# SERVICE BULLETIN REVISION NOTICE

ENGINE — SEALS, BLADE OUTER AIR (DUCT SEGMENTS), 1ST AND 2ND STAGE HIGH PRESSURE TURBINE (HPT) — REPLACE OR MODIFY TO IMPROVE EFFICIENCY

Turbojet Engine Service Bulletin No. V2500-ENG-72-0634 Revision No. 1 dated February 27, 2014.

# V2500-ENG-72-0634

HPT CASE AND VANE ASSEMBLY — PART MARKING LOCATION  
FIGURE 1

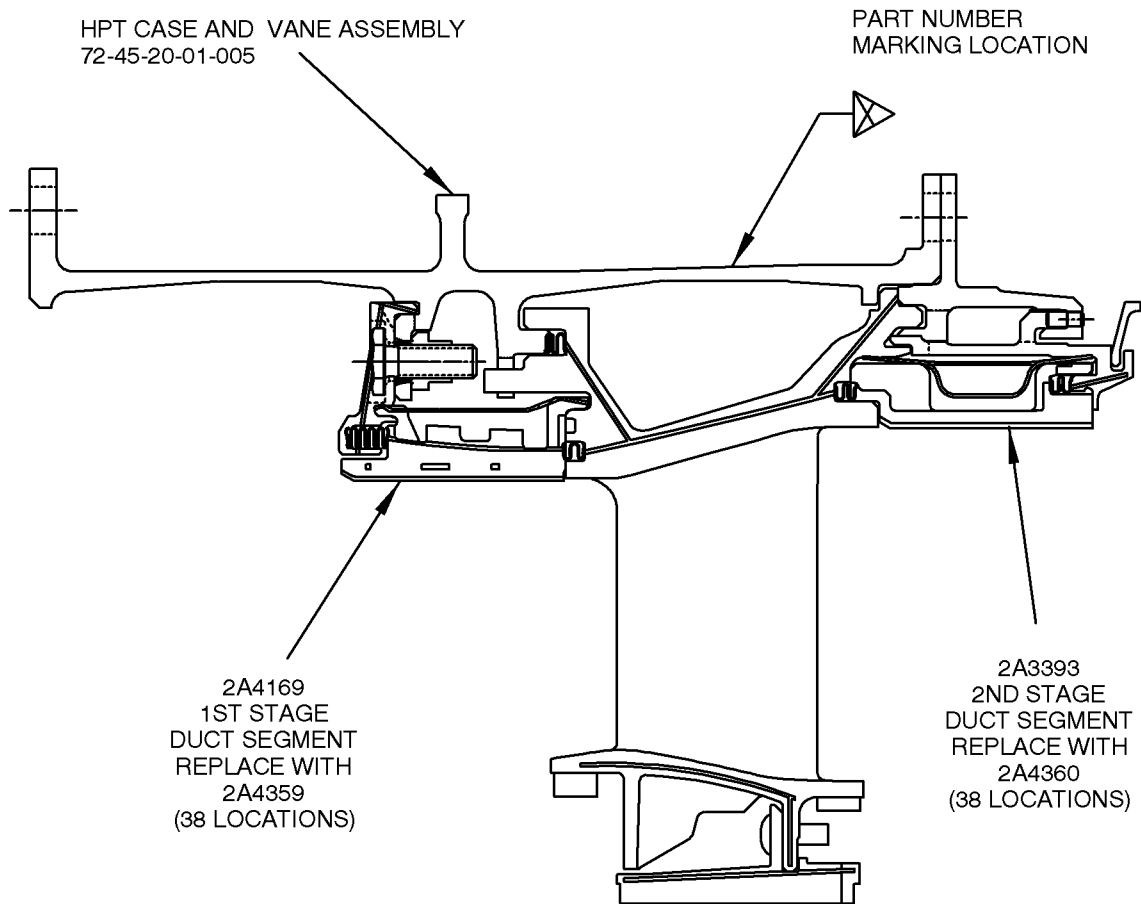
- (4) Reidentify the modified HPT case and vane assembly using the vibration peen method as described in Reference 2, V2500-A5 Standard Practices Manual, Section 70-09-00. Locate new part marking location as shown in Figure 1. The reidentification part numbers are as follows.

- (4) Reidentify the HPT case and vane assembly using the vibration peen method as described in Reference 2 or 3, V2500-A5/D5 Standard Practices/Processes manual, Section 70-09-00. Locate new part marking location as shown in Figure 1. The reidentification part numbers are as follows.

New PN	Old PN
2A4370	2A4387
2A4370	2A4087-002

New PN	Old PN
2A3469-005	2A3219-003
2A3469-005	2A3469-004
2A3469-005	2A3416-005
2A4390	2A4050

HPT ROTOR AND STATOR ASSEMBLY  
FIGURE 2, SHEET 1

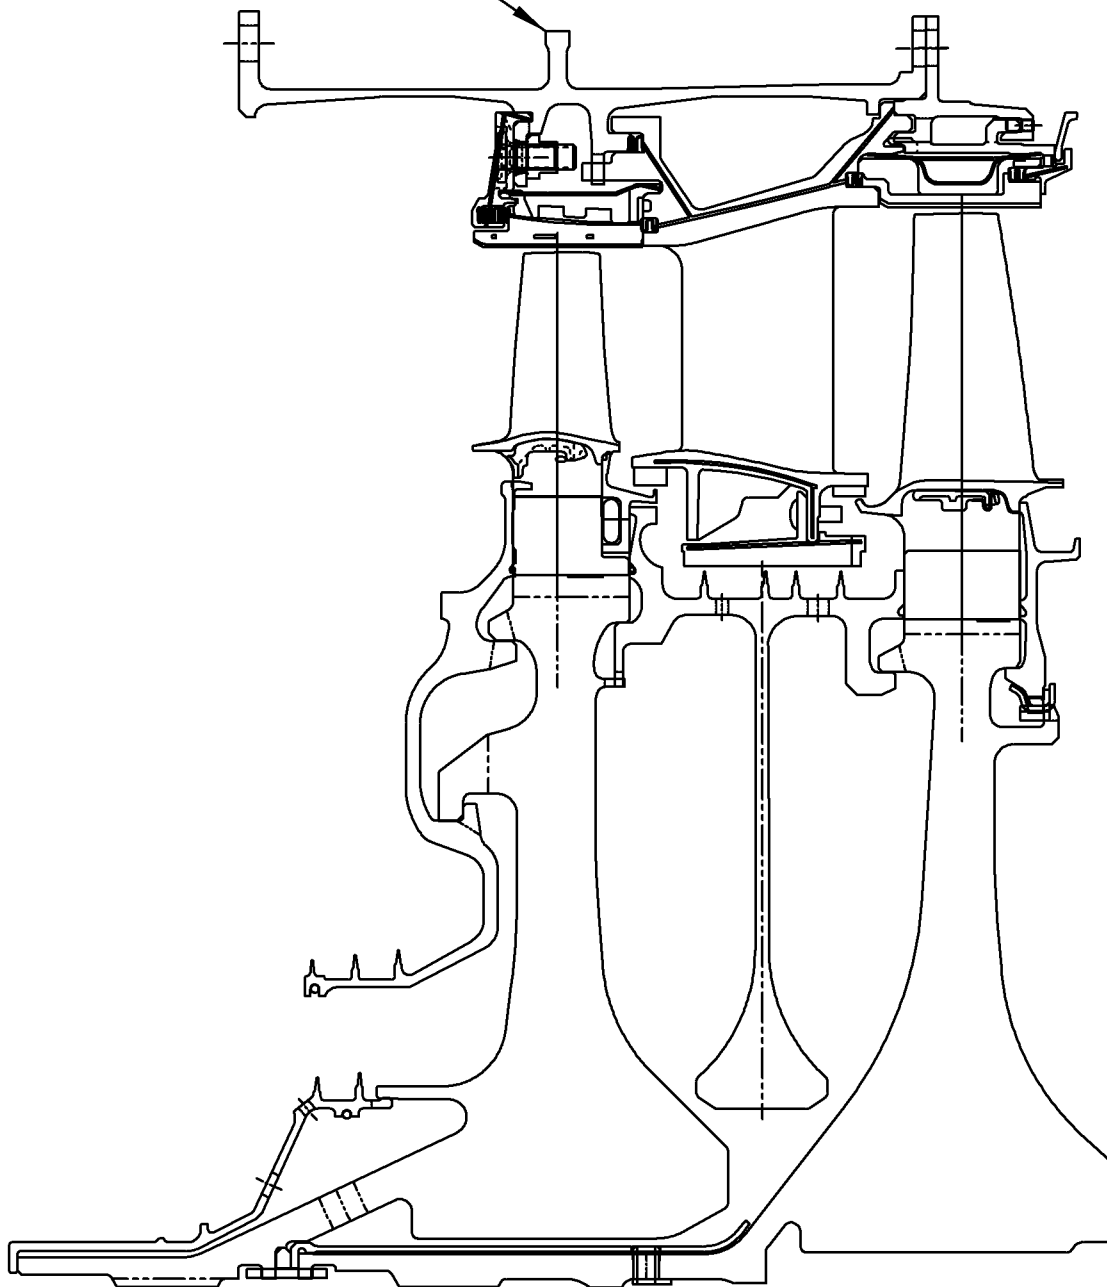
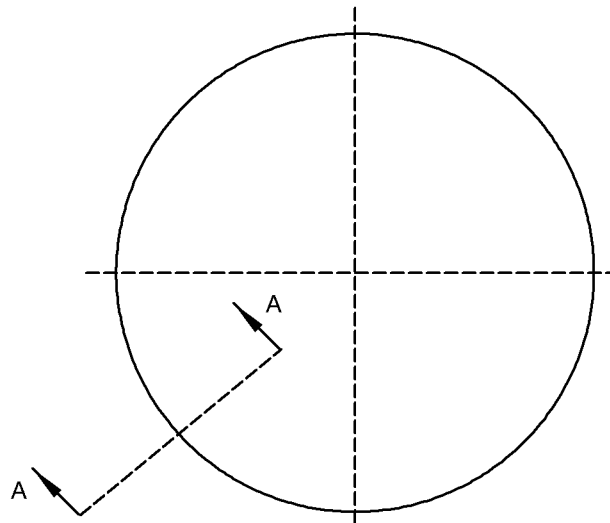
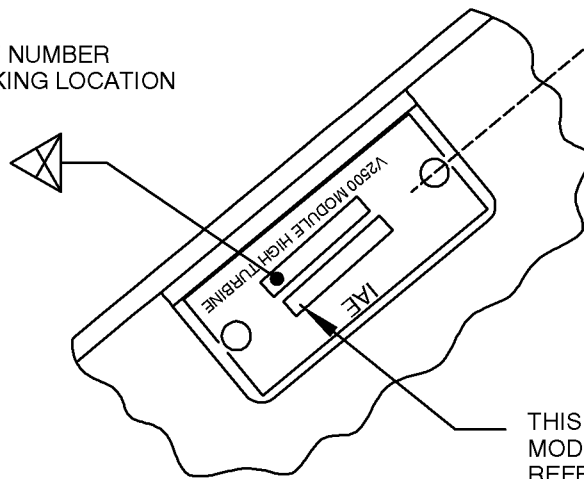
- B. Install the modified HPT case and vane assembly into the HPT rotor and stator assembly, per Reference 7, V2500 A5 Engine Manual Task 72-45-00-430-001-D00.
- C. Reidentify the HPT rotor and stator assembly using the vibration peen method as described in Reference 2, V2500-A5 Standard Practices manual, Section 70-09-00. Locate new part marking location as shown in Figure 2. The reidentification part numbers are as follows:

- B. Install the modified HPT Case and Vane Assembly into the HPT Rotor and Stator Assembly per Reference 7, V2500 A5 Engine Manual Task 72-45-00-430-001-C00 (or) Reference 8, V2500 D5 Engine Manual Task 72-45-00-430-001.
- C. Reidentify the HPT Rotor and Stator Assembly using the vibration peen method as described in Reference 2 or 3 V2500-A5/D5 Standard Practices manual, Section 70-09-00. Locate new part marking location as shown in Figure 2. The reidentification part numbers are as follows:

New PN	Old PN
2A4380	2A4350
2A4380	2A4250-002

New PN	Old PN
2A9800-002	2A9800-001
2A9300-009	2A9300-006
2A7000-032	2A7000-016
2A9300-009	2A7000-019
2A4470	2A4310

FAMILY TREE — STAGE 1 HIGH PRESSURE TURBINE DUCT SEGMENT  
(V2500 A5 SELECTONE™ CONFIGURATION)  
REF CATALOG SEQUENCE NO. 72-45-23-01-060  
CHART C

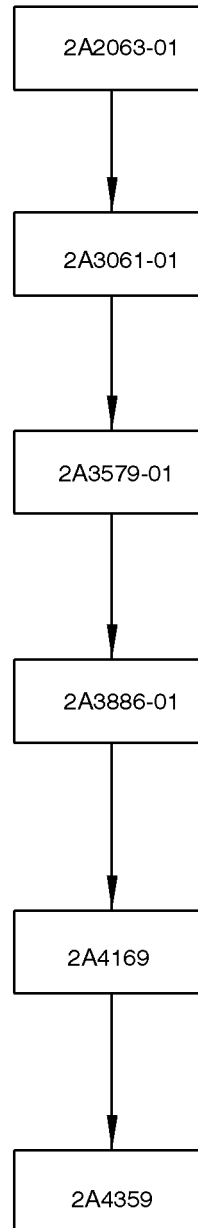
V2500-ENG-72-0634  
ENGINE - SEALS, BLADE  
OUTER AIR (DUCT SEGMENTS)  
1ST AND 2ND STAGE HIGH  
PRESSURE TURBINE (HPT) -  
REPLACE OR MODIFY TO  
IMPROVE EFFICIENCY

FAMILY TREE — STAGE 2 HIGH PRESSURE TURBINE DUCT SEGMENT (V2500 A5  
SELECTONE™ CONFIGURATION, V2500 A5 STANDARD AND V2500 D5)  
REF CATALOG SEQUENCE NO. 72-45-25-01-060  
CHART D

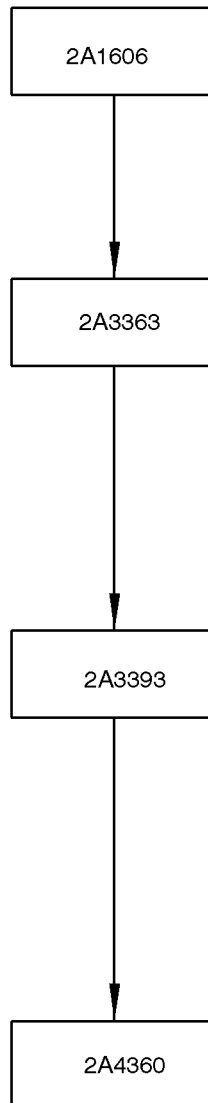
V2500-ENG-72-0634  
ENGINE - SEALS, BLADE  
OUTER AIR (DUCT SEGMENTS)  
1ST AND 2ND STAGE HIGH  
PRESSURE TURBINE (HPT) -  
REPLACE OR MODIFY TO  
IMPROVE EFFICIENCY
